HAM/WAR US 22  
16.04/0.00 PED  
HAMILTON COUNTY  
WARREN COUNTY

REVIEW COMPLETE

PROJECT DESCRIPTION

RELOCATING EXISTING PED HEADS AND PUSH BUTTONS ONTO PEDESTALS FOR BETTER ACCESSIBILITY, ADDING SIDEWALK AND CURB RAMPS TO MAKE CROSSINGS ADA COMPLIANT. INCLUDES PEDESTALS AND ASSOCIATED CONDUIT, WIRING AND PULLBOXES ALONG US-22 IN HAMILTON AND WARREN COUNTIES

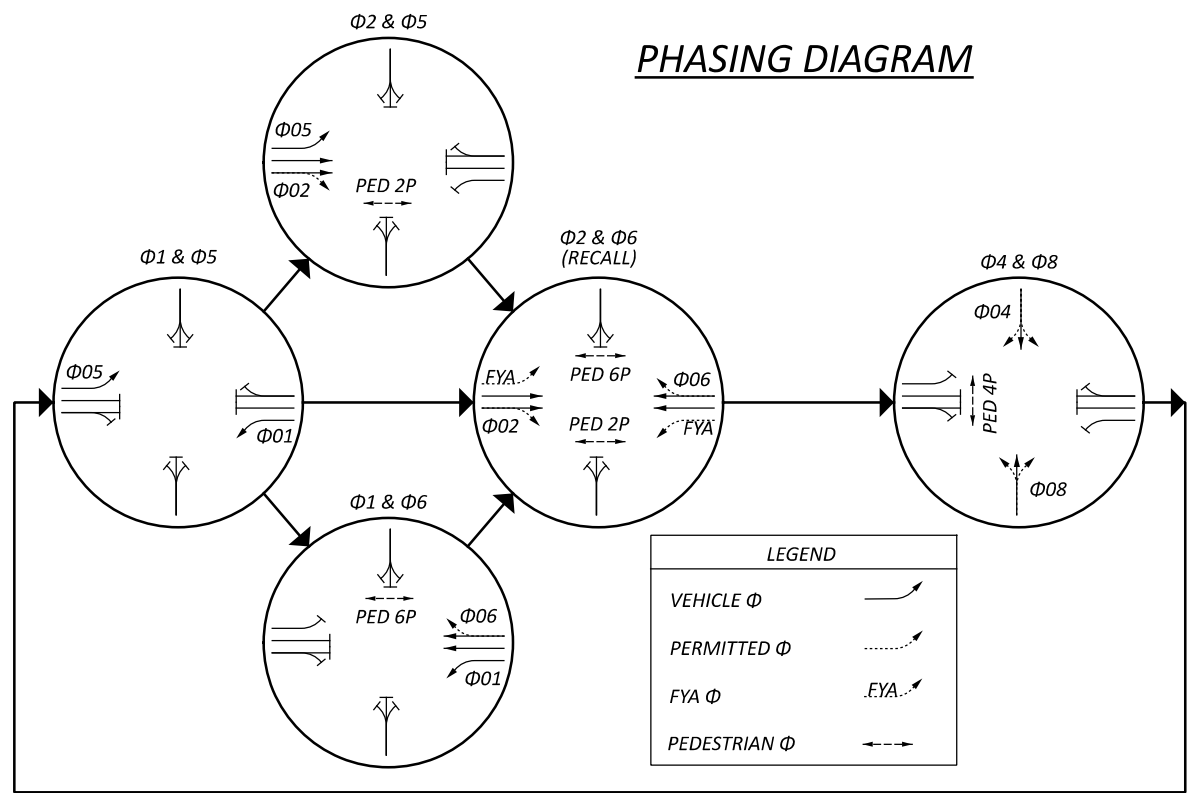
GENERAL COMMENT: It may be easier to discern the proposed work if all existing times to remain are stated as EX (rather than a number) or use a fine linetype. Make the proposed changes stand out in BOLD.

**TRAFFIC SIGNAL PLAN  
 US 22 AT MASON RD/SYMMES CREEK DR**

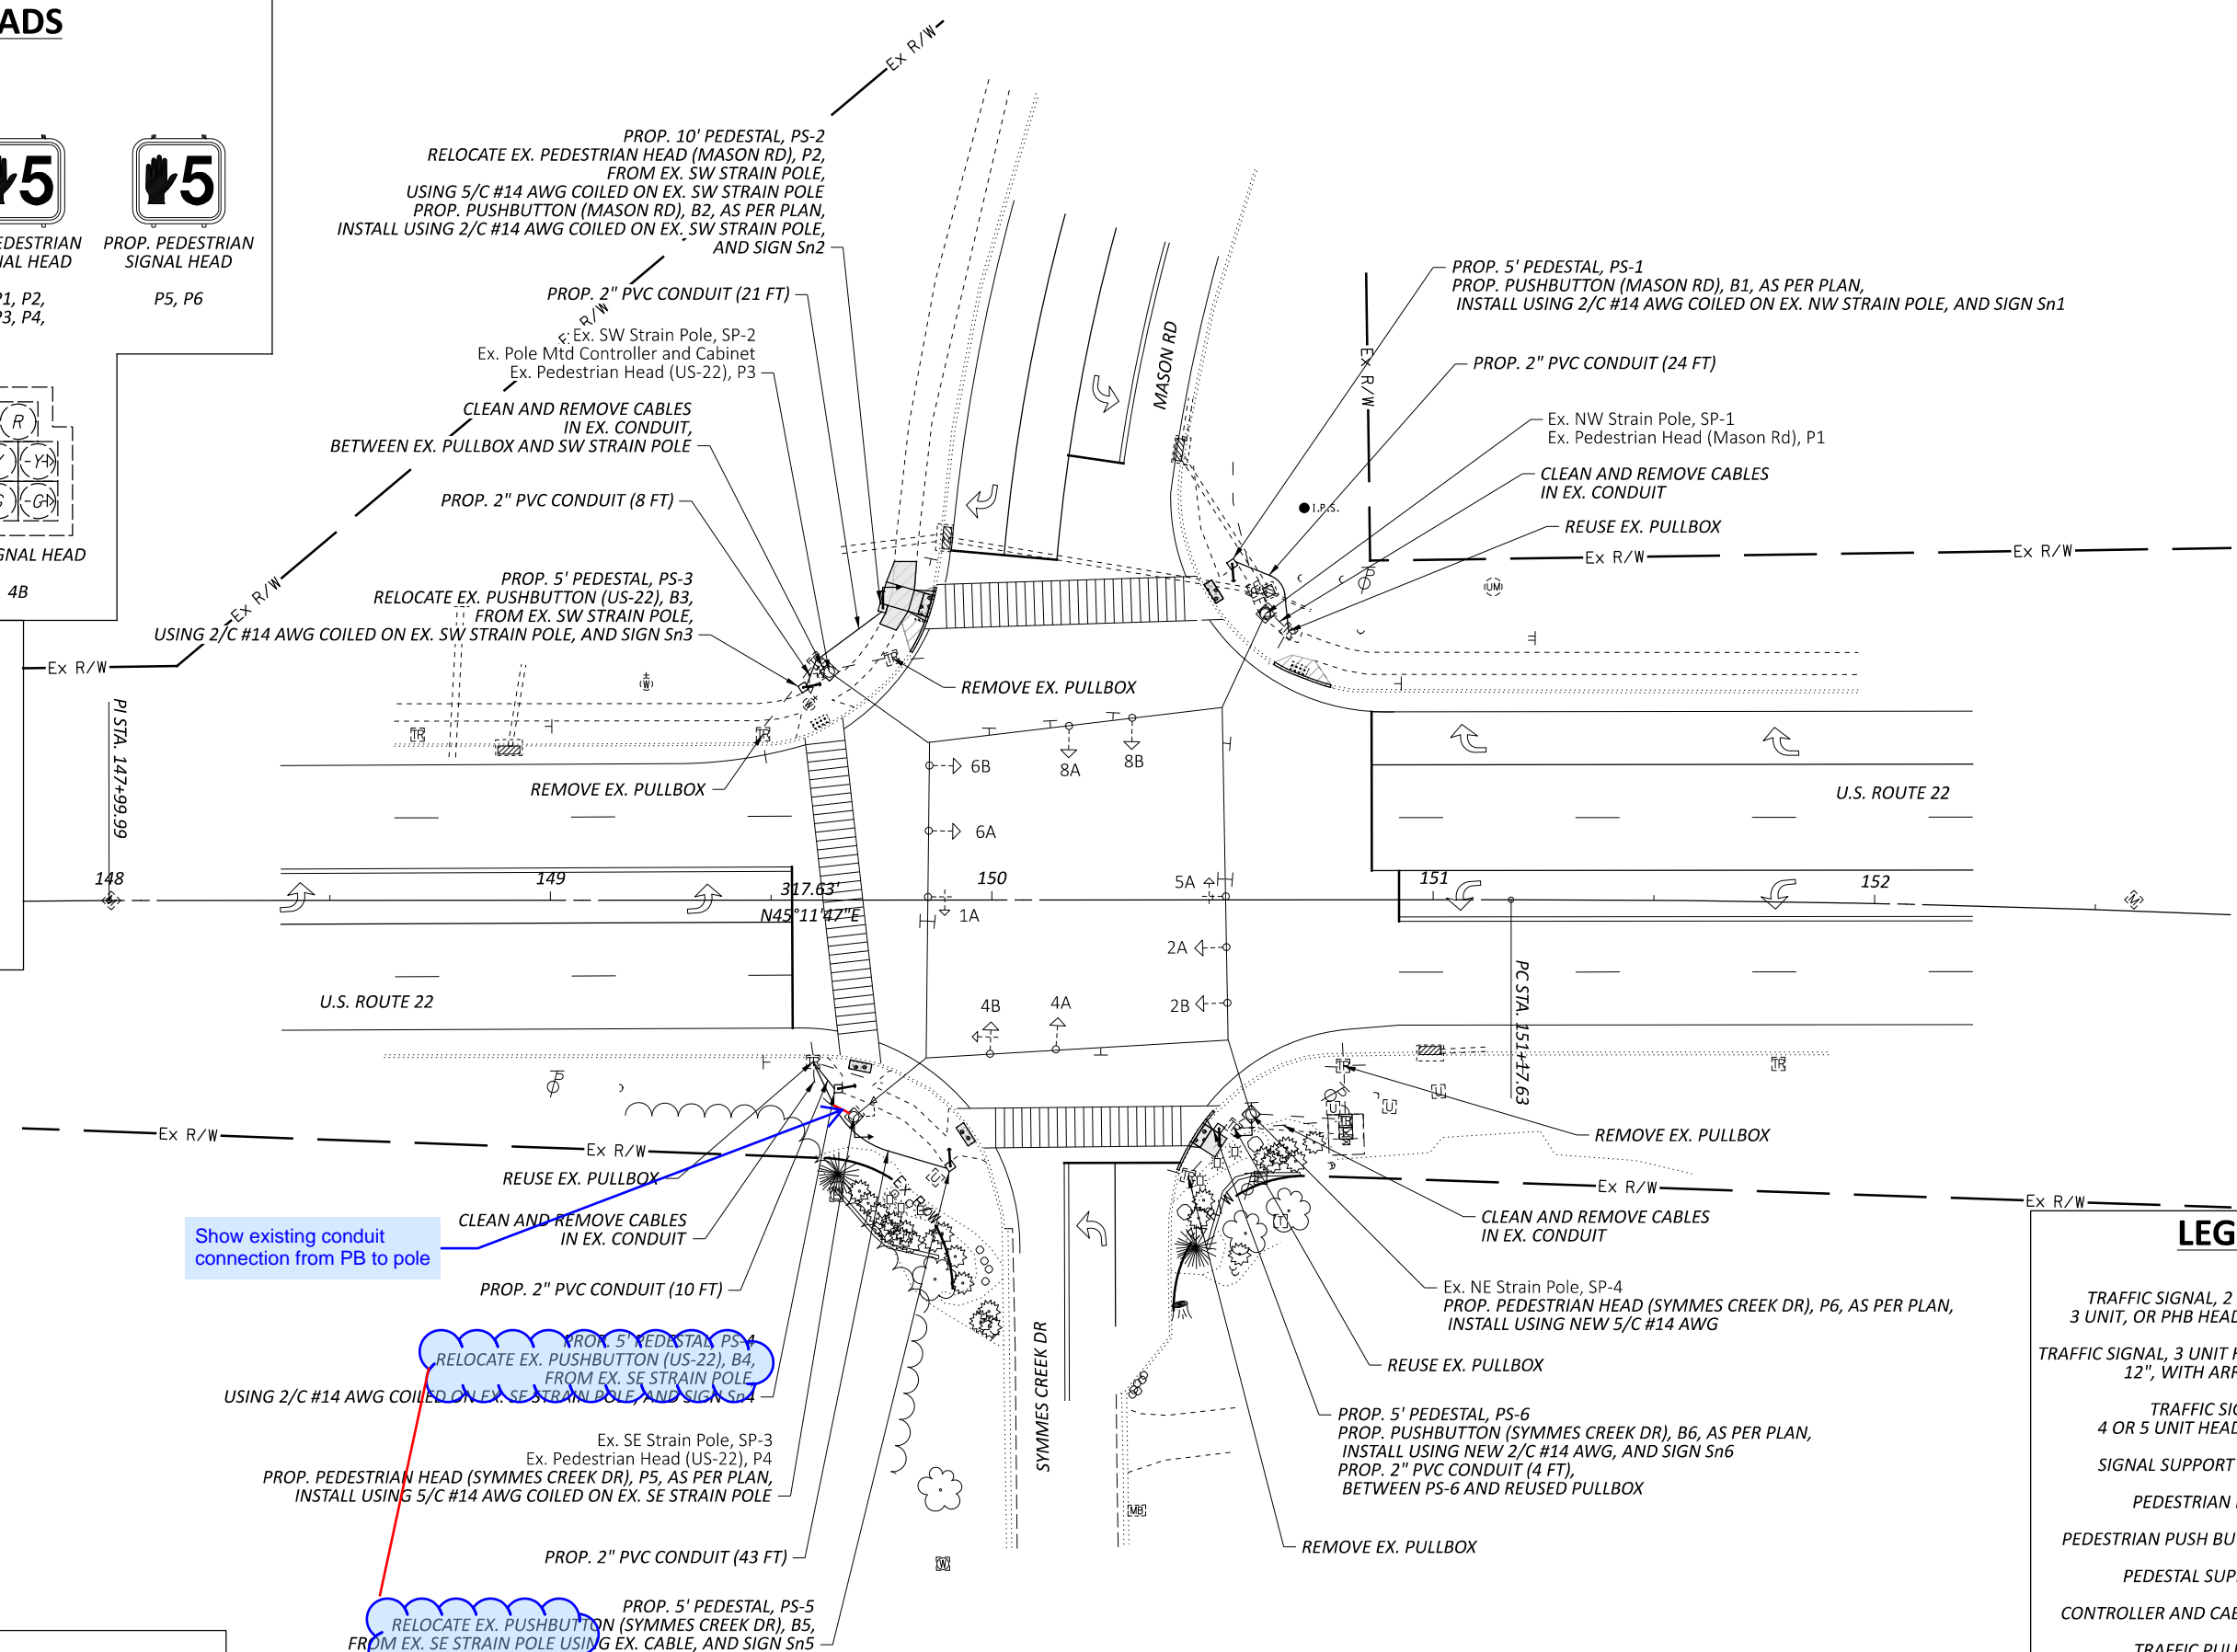
Show existing conduit connection from PB to pole

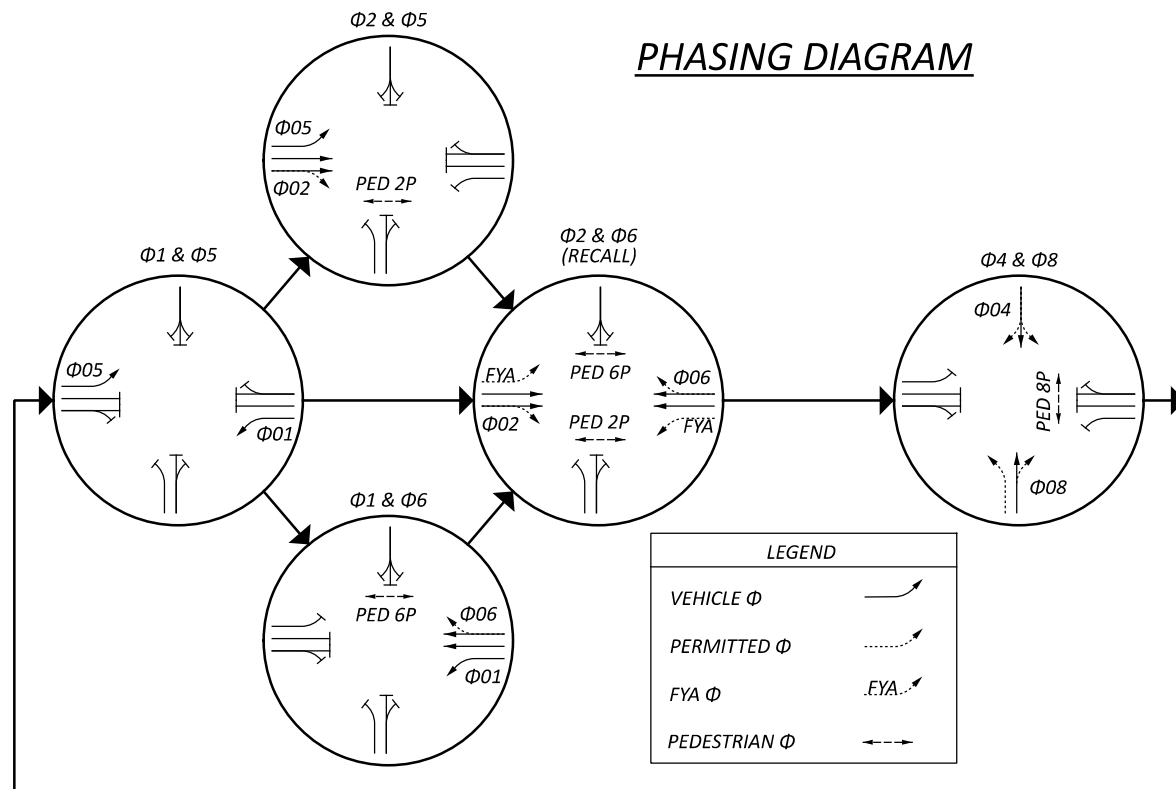
7 and 6 per calculations

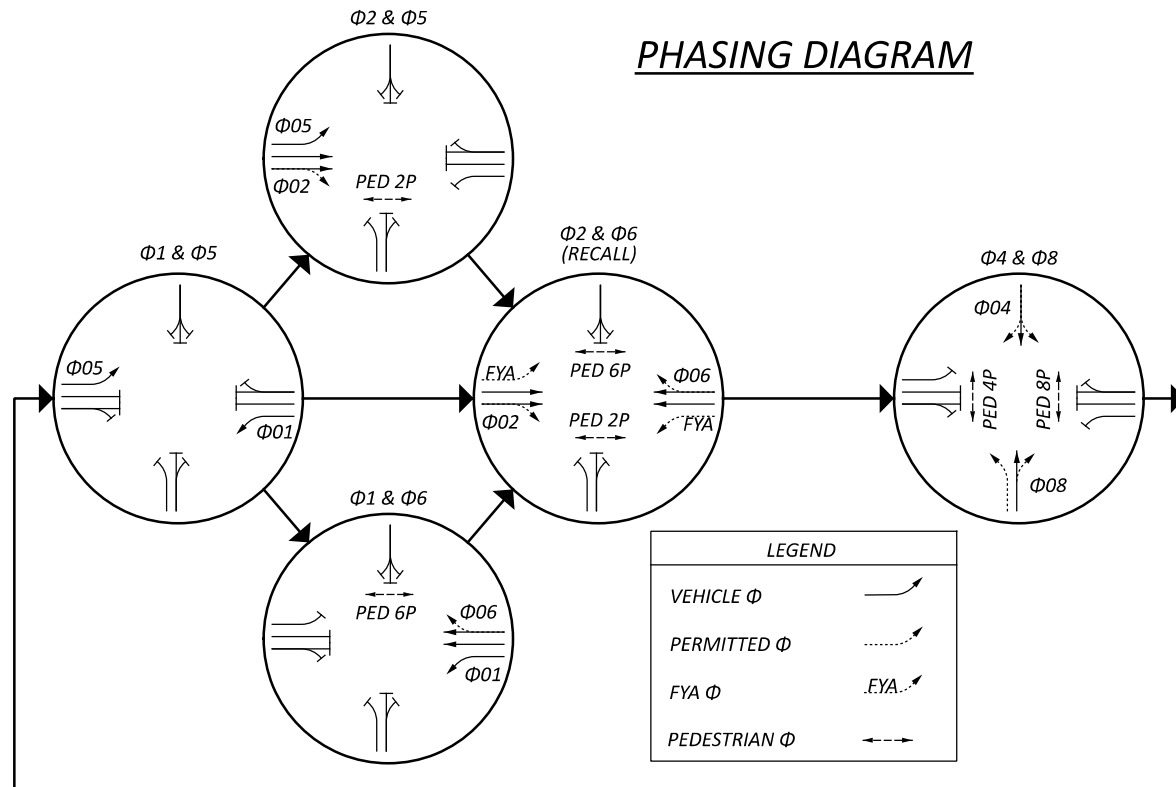
Round to nearest 0.5 sec. Use 2 sec min for AR

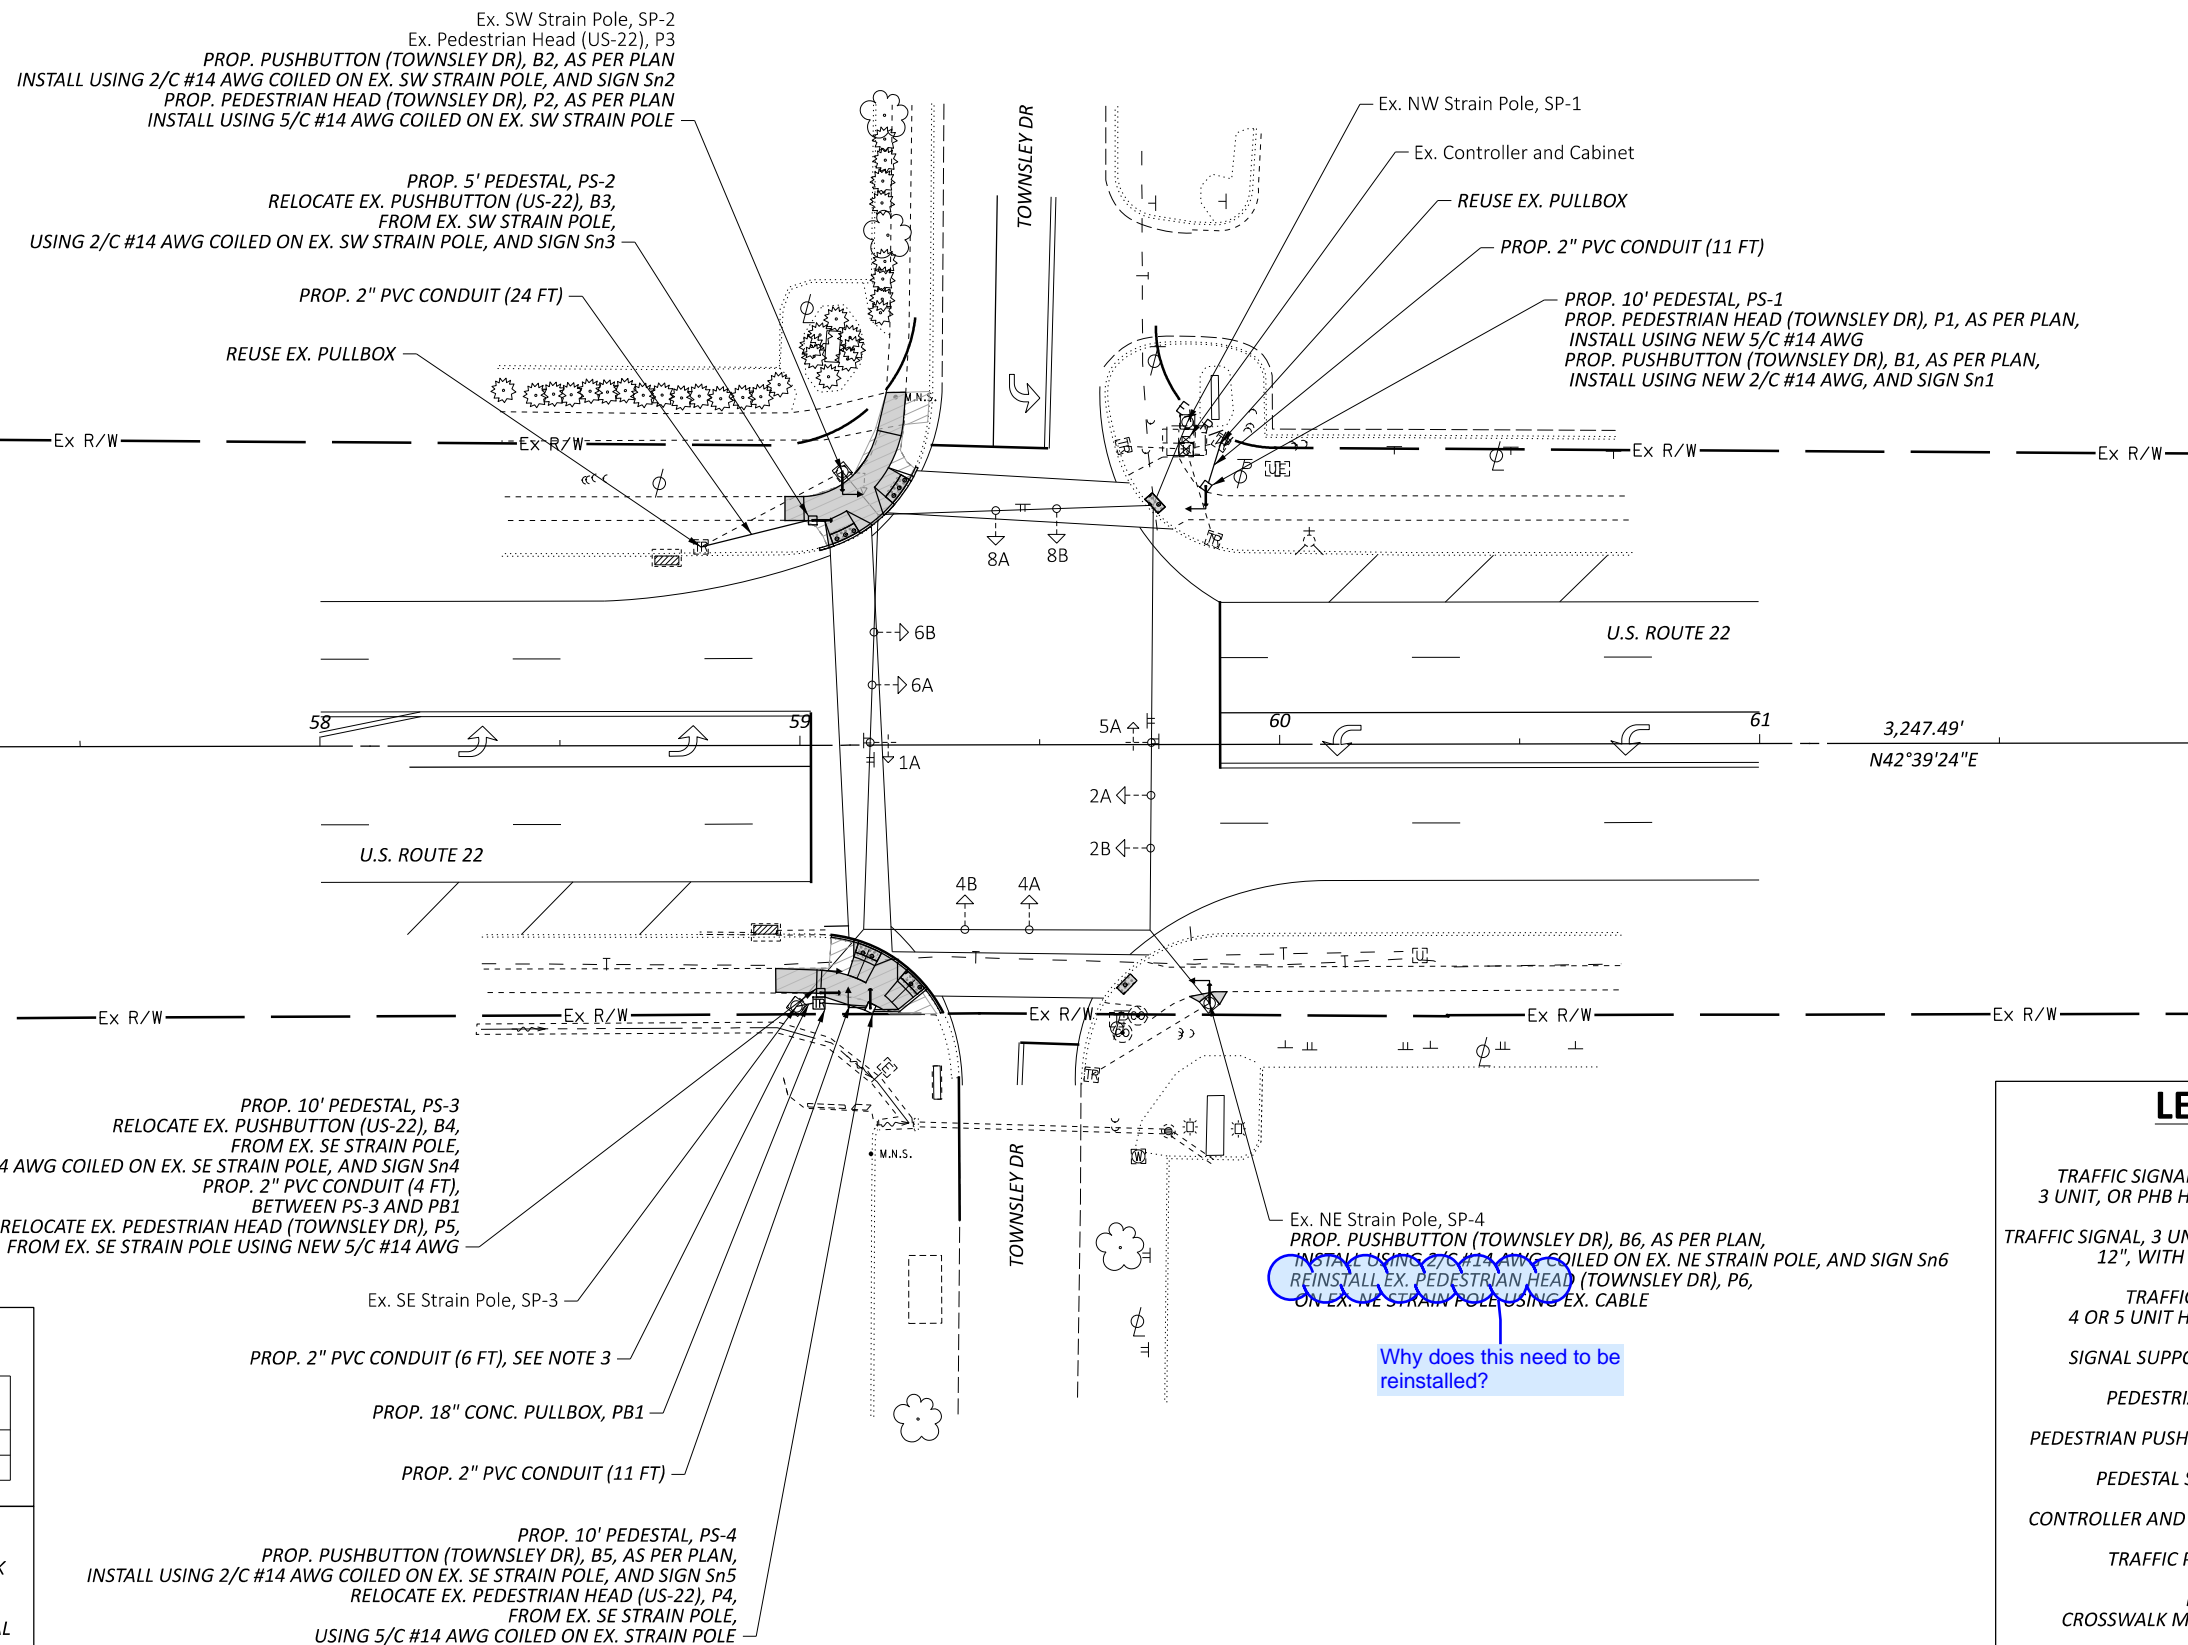
Why does this need to be reinstalled?

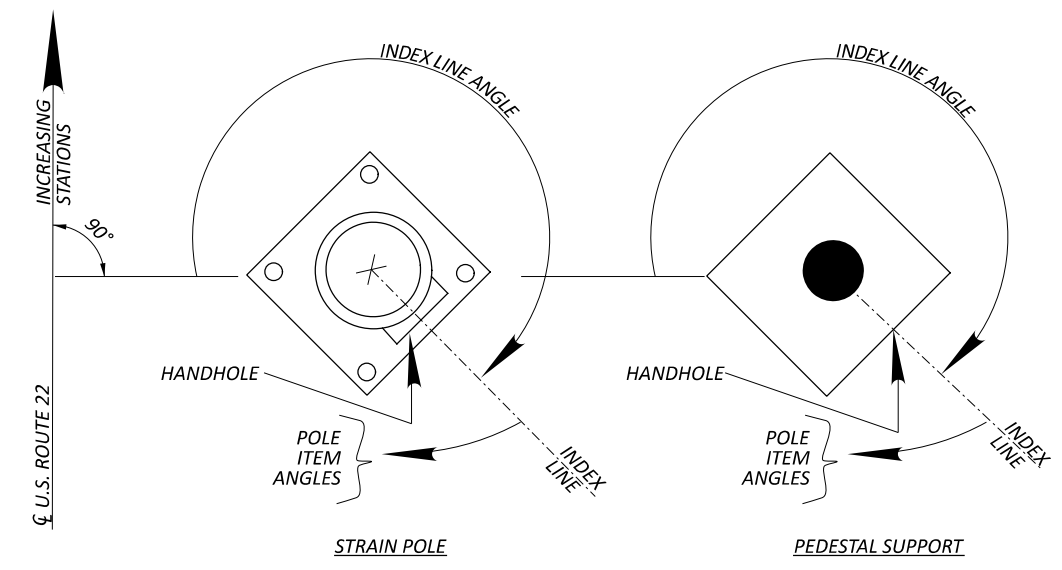
typo?
